INITIAL FIRE SAFETY INSPECTION REPORT

Colour & Co. Ltd

RSC ID: 25528

Date: 03-Mar-2024

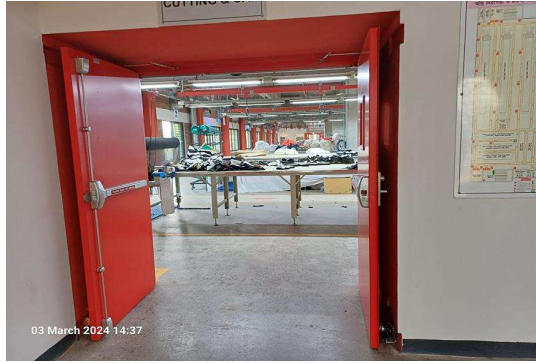
SI No.	Category	Findings	Required Action	Remediation Time Frame
F-1	Fire Rated Construction	Areas used for combustible storage open to the factory are not separated by fire rated construction. Location: 3rd floor in Main Production Building .	Separate the dedicated storage rooms by minimum 1-hr fire-rated construction. Provide 0.75 hr. fire rated door and seal all penetrations and openings by 1 hr. fire rated fire rated barrier construction. Where separate storage rooms are not feasible, provide defined storage areas and limit the storage arrangement as follows: Where the building/floor is sprinkler protected: maximum height of 3.66m (12ft.) and maximum area of 93m2 (1000 ft2) and 3m (10ft.) clear distance from adjacent another unenclosed combustible storage.	Within 3 Months
